STATE OF NORTH CAROLINA
DEPARTMENT OF TRANSPORTATION

Addendum No. 1
RE: Contract # C204039
WBS # 34243.3.2
STATE FUNDED
Polk County (I-4729A)
I-26/US-74/NC-108 Interchange Modifications in the Town Of Columbus

September 19, 2017 Letting

The following revisions have been made to the Roadway plans:

14-AUG-2017 08:18
J:\I-4729A\Roadway\XSC\I-4729A_Rdy_xpl.dgn
$$$$USERNAME$$$$

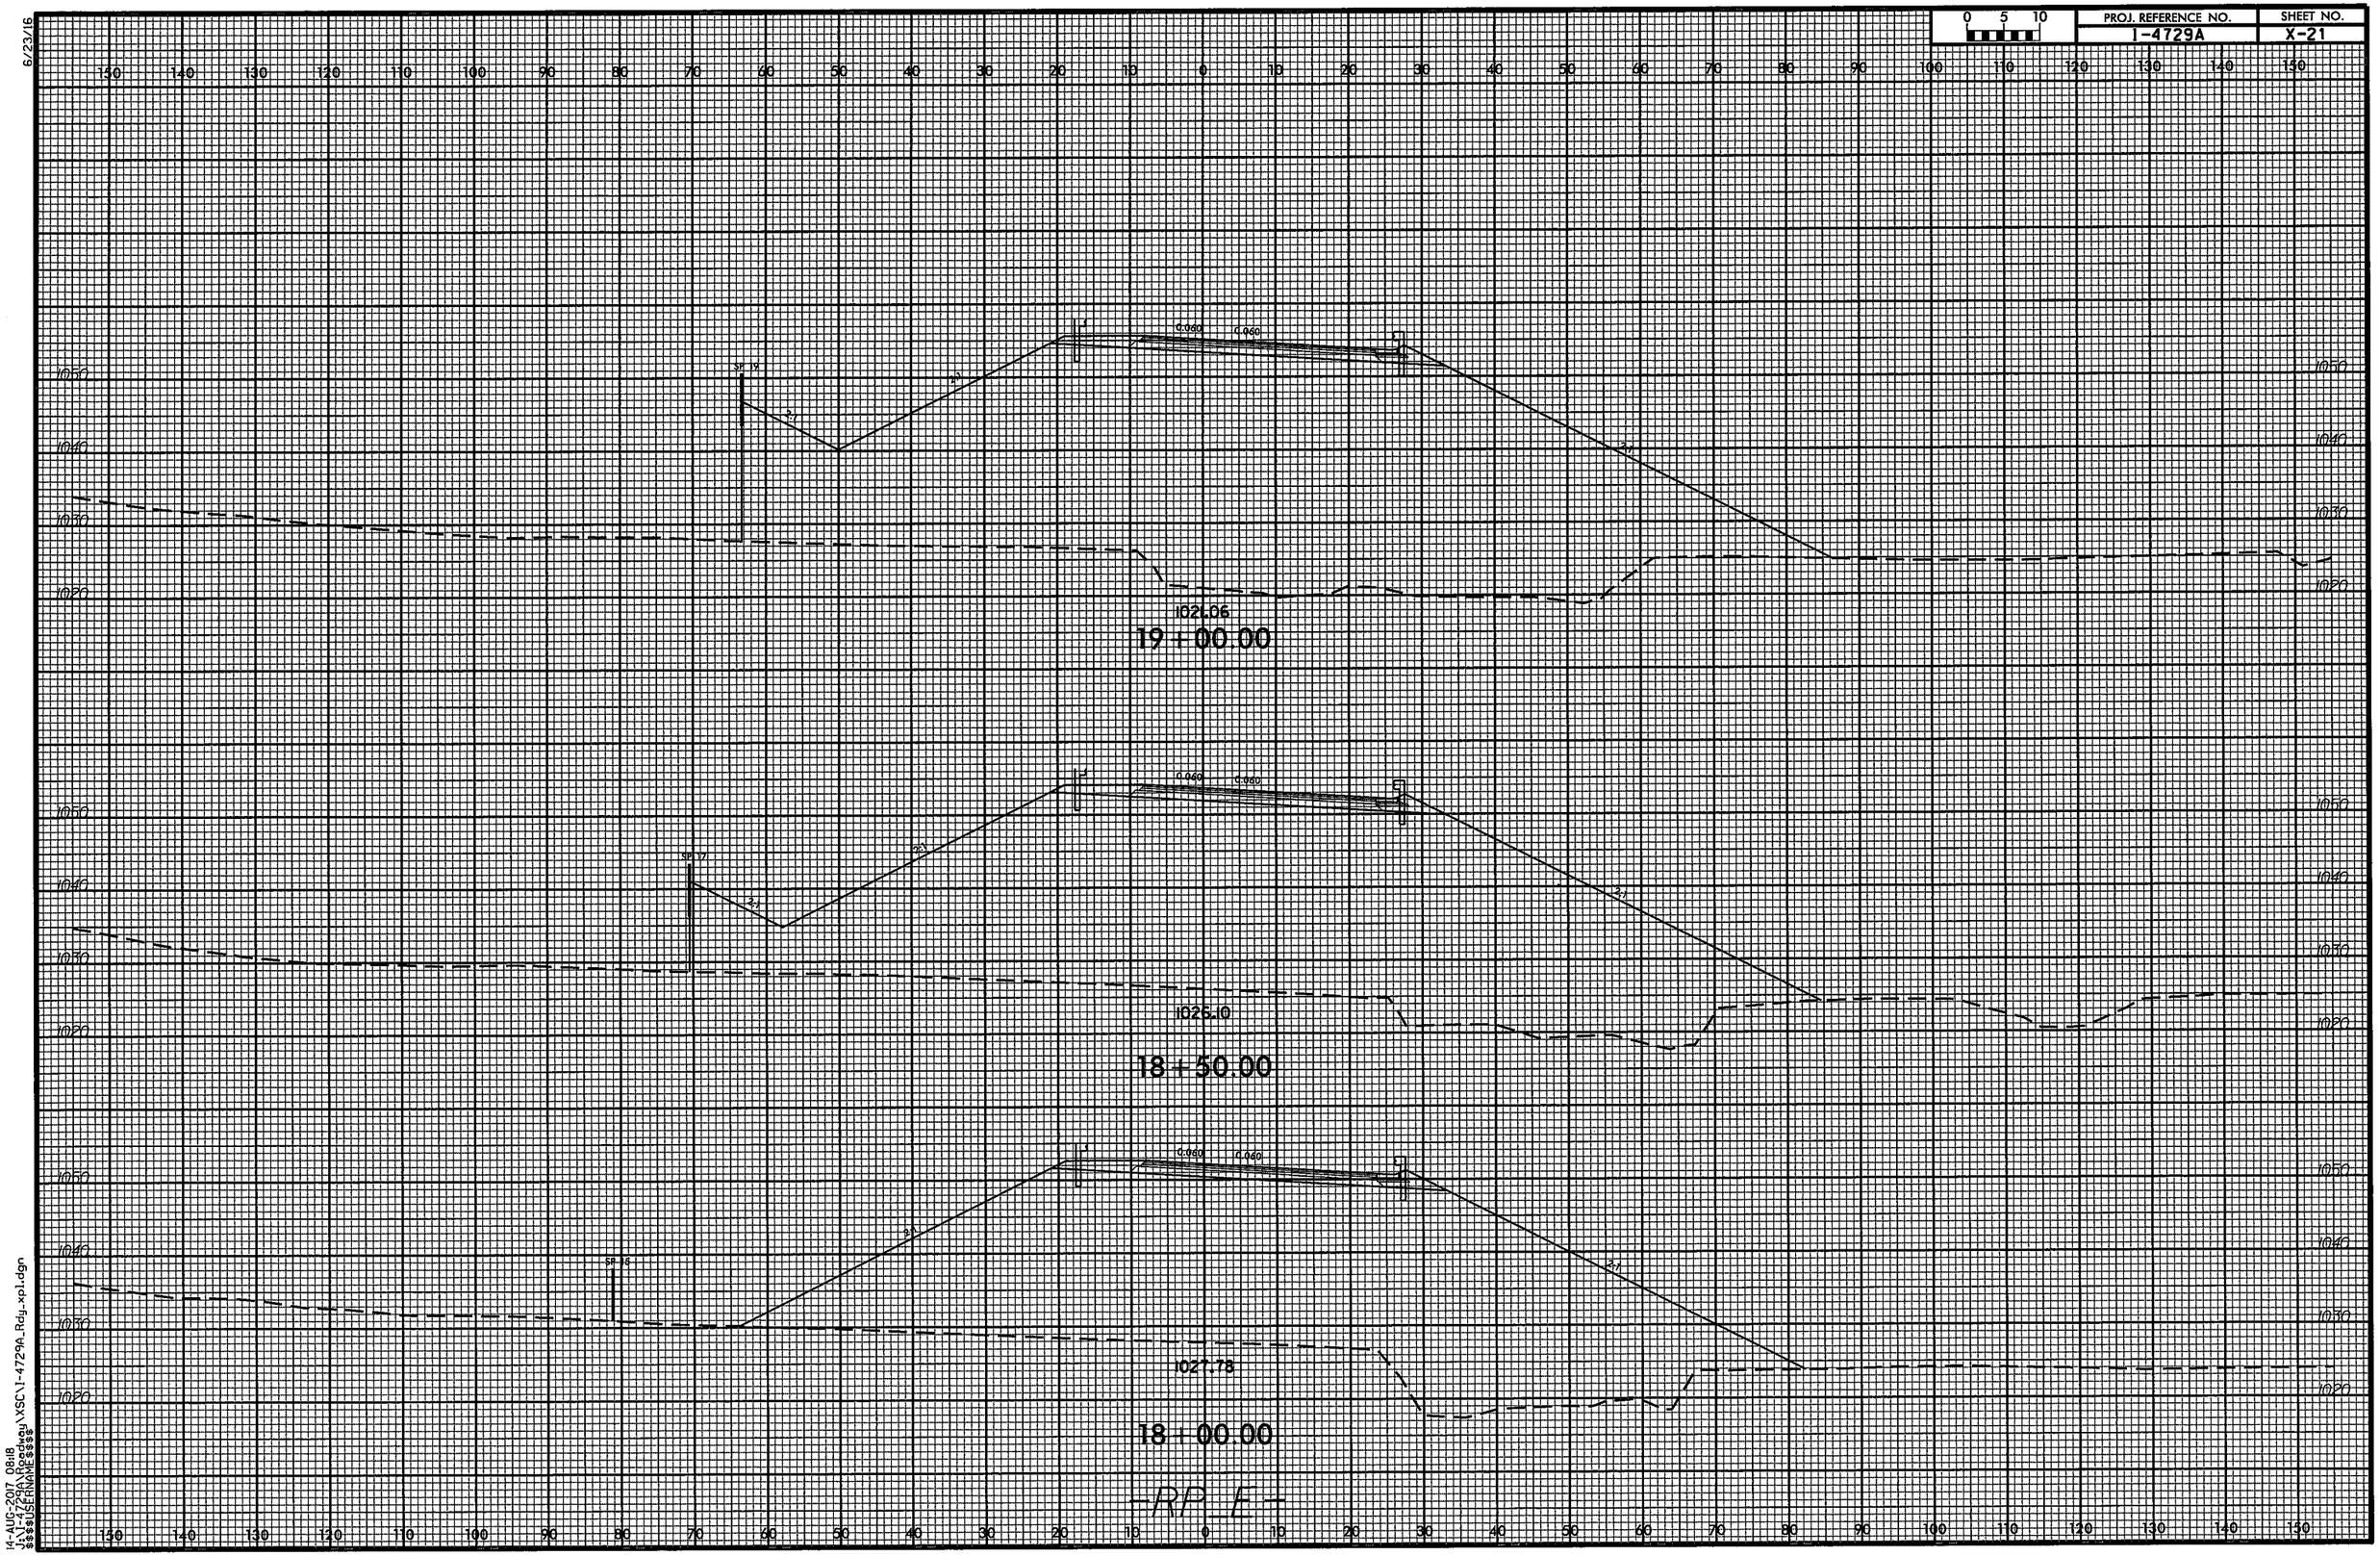
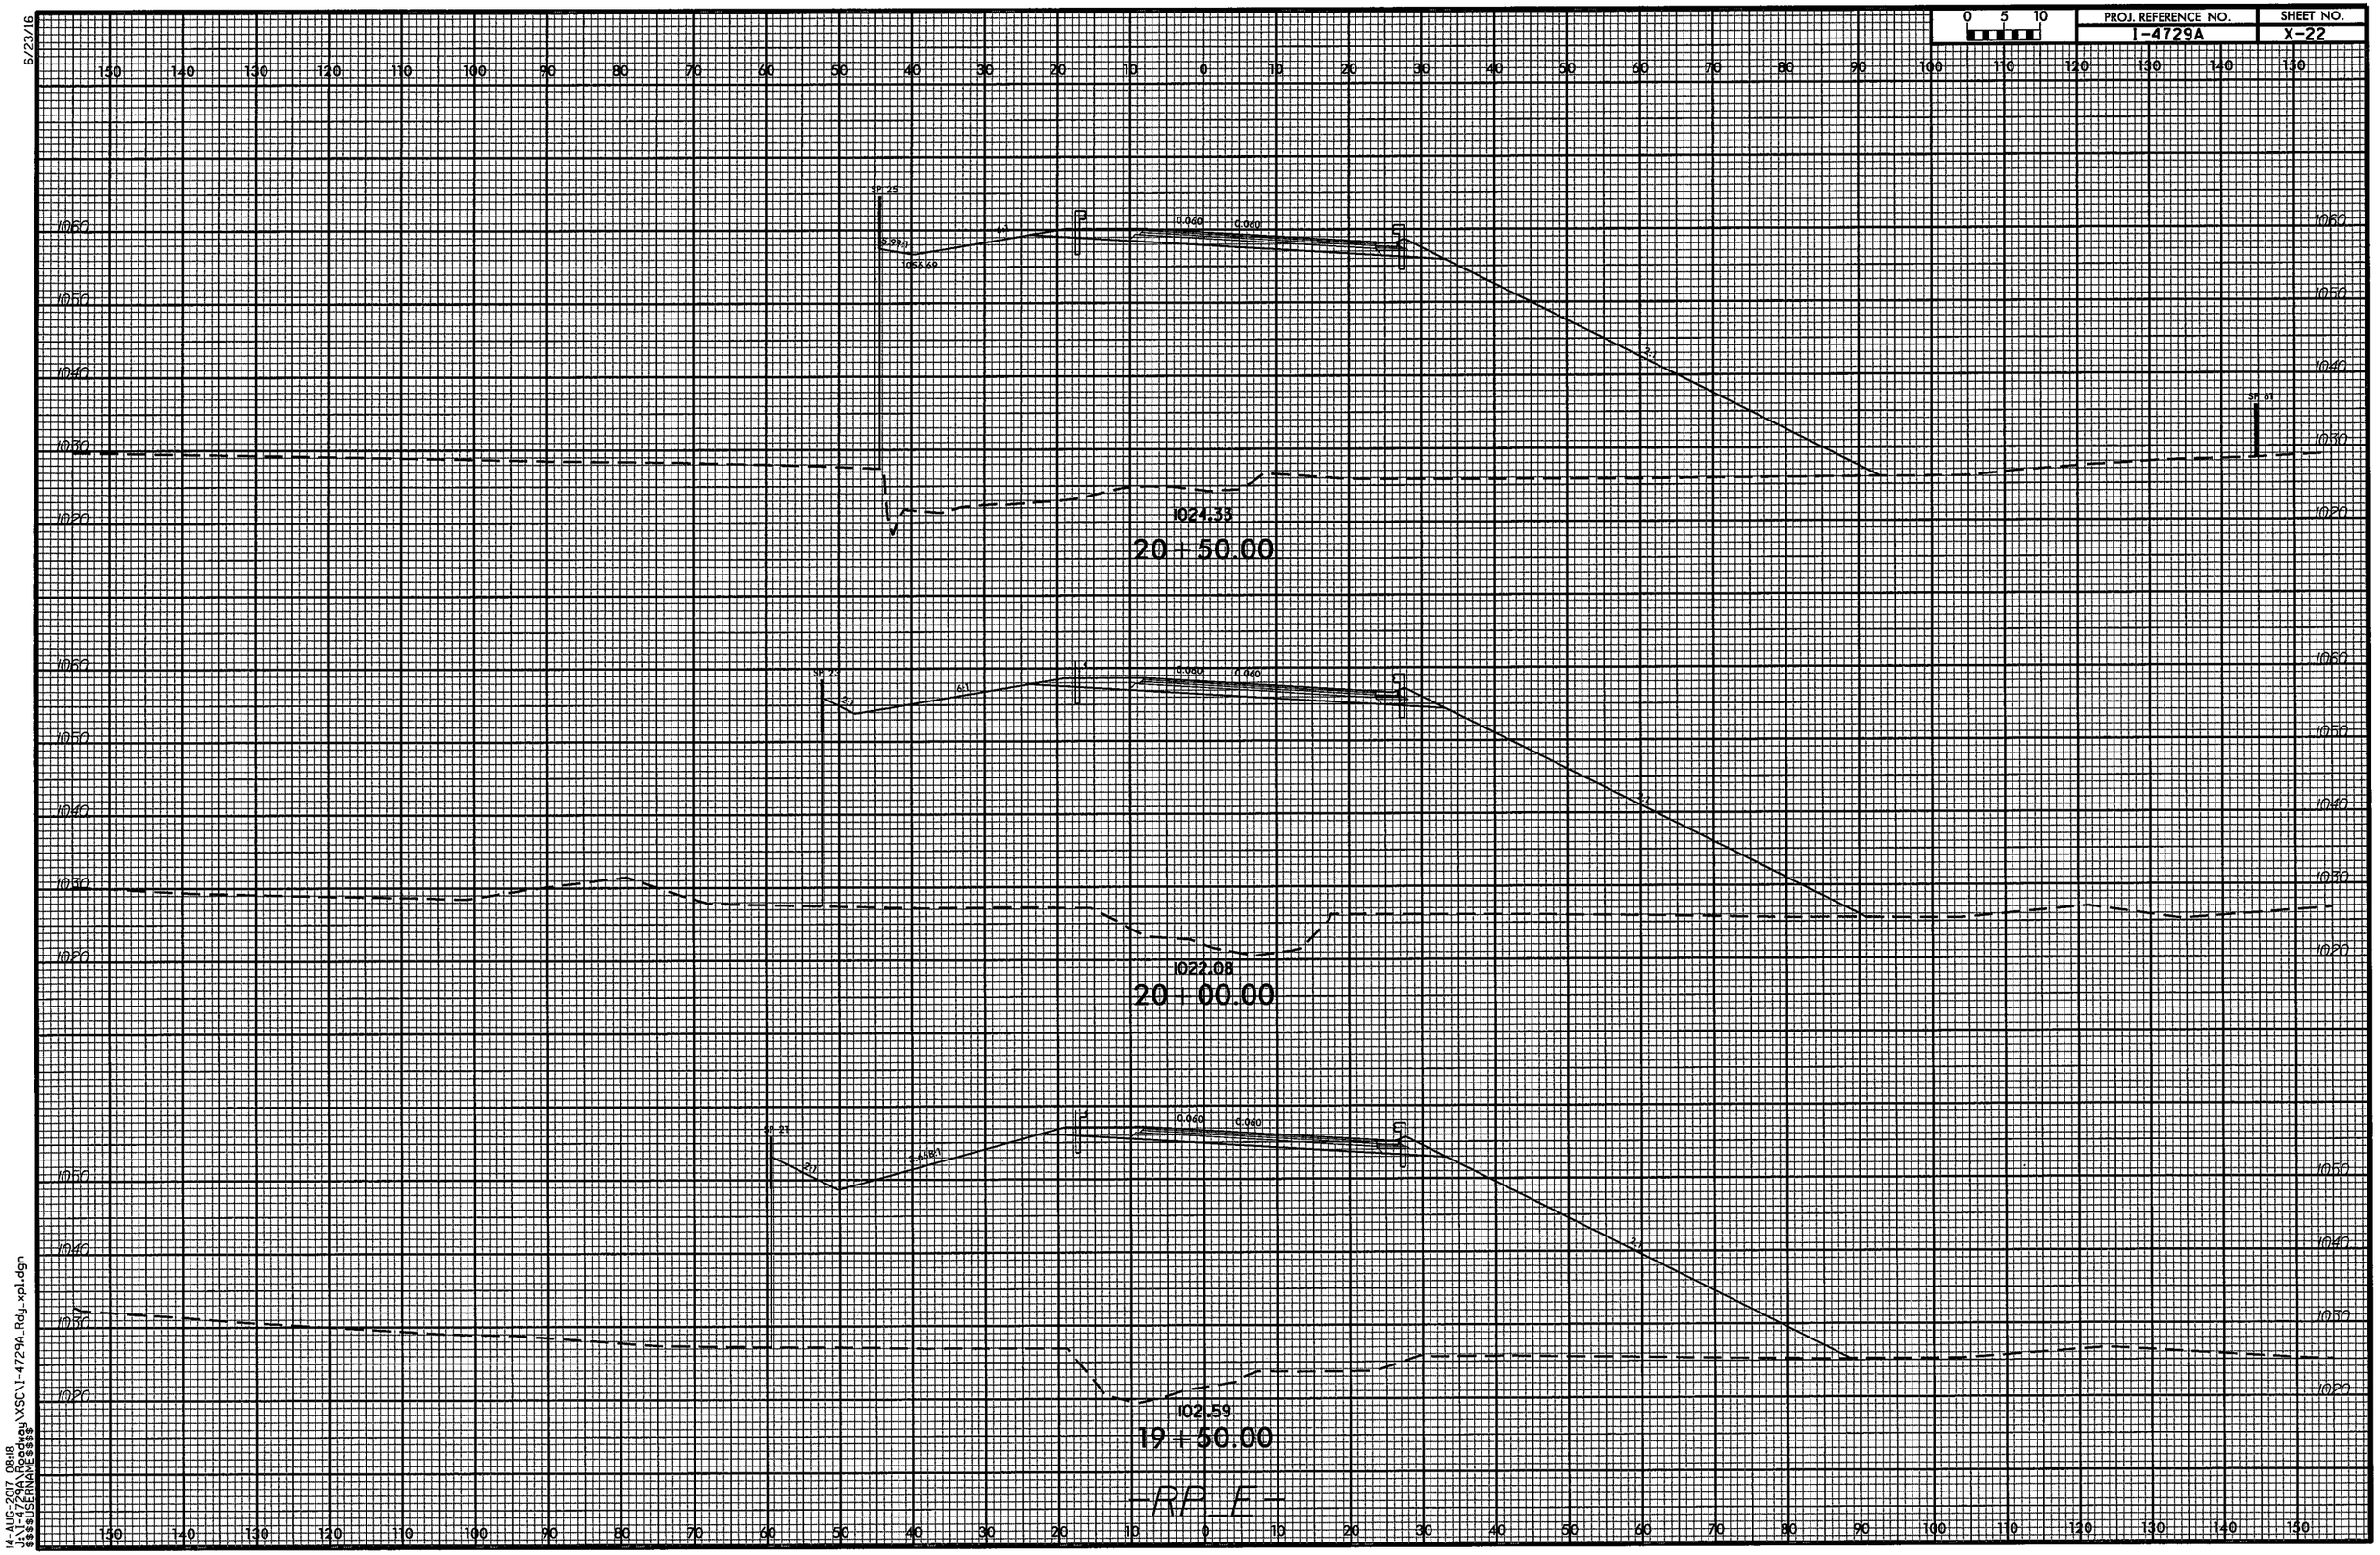
Sheet No.	Revisions
1A	Revised Index of Sheets to remove 2G-2 "Standard Embankment Monitoring Detail" and revise the number of" Drainage Summaries" sheets
2A-1, 2A-4 and 2A-5	Revised the Typical Sections for the change in mainline pavement widening design from ABC to Asphalt Base
3B-1	Revised 'Summary of Earthwork' to account for pavement widening design change
3D-1 thru 3D-4	Various drainage quantity changes as noted below
3G-1	Removed "Settlement Gauge Summary" and added note that Bridge Waiting Period only applies to Approach Slab construction
5	Revised to require Welded Steel Pipe by Trenchless method under the Interstate 26
X-1A thru X-87	Revised Cross-Sections to reflect the change in Earthwork due to the pavement design change
